Access Compliance Report

Public Rights-of-Way

(Curb Ramps)

Intersection ID: 50583	Main Street: GRAND_FIR_RD	Cross Street: LONGSTRAW_RD	Location: NW
ADA ID: C6146290B27C	Ramp Type: Perp	Initial Pass/Fail: Fail	Overall Compliance: No
		Severity Score: 22.5

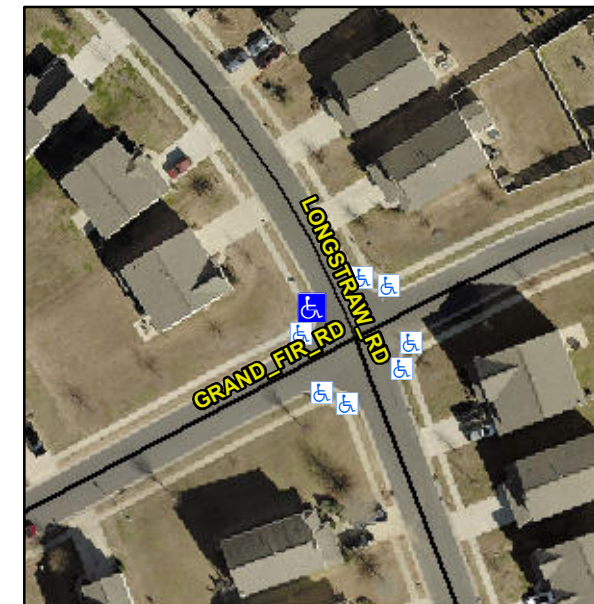
Not Found, R304.5.1, R304.2.2, R304.5.3

Compliance	Description	Data	Compliance	Description	Data
N/A	Ramp Length (in)	49.0	No	Ramp Slope (%)	9.2
No	Ramp Width (in)	47.0	No	Ramp XSlope (%)	3.6
N/A	Flare Type LT	N/A	N/A	Flare Type RT	N/A
N/A	Flare Slope LT (%)	N/A	N/A	Flare Slope RT (%)	N/A
N/A	Flare Traversable LT?	N/A	N/A	Flare Traversable RT?	N/A
N/A	Landing Length (in)	N/A	N/A	DWS Provided?	N/A
N/A	Landing Width (in)	N/A	N/A	DWS Contrast?	N/A
N/A	Landing Slope (%)	N/A	N/A	DWS Length (in)	N/A
N/A	Landing X Slope (%)	N/A	N/A	DWS Full Width?	N/A
N/A	Landing Curb? (Y/N)	N/A	N/A	DWS Offset (in)	N/A
N/A	Shared Landing?	N/A			
N/A	Gutter Ponding?	N/A	N/A	Gutter Slope (%)	N/A
N/A	Gutter Lip Ht (in)	N/A	N/A	Gutter X Slope (%)	N/A
N/A	Painted X Walk1?	No	N/A	Painted X Walk2?	N/A
	X Walk 1 Direction	To E		X Walk 2 Direction	N/A
N/A	X Walk 1 Width (in)	N/A	N/A	X Walk 2 Width (in)	N/A
	X Walk 1 Slope (%)	2.8		X Walk 2 Slope (%)	N/A
	X Walk 1 X Slope (%)	6.1		X Walk 2 X Slope (%)	N/A

Remove & Replace Entire Ramp.
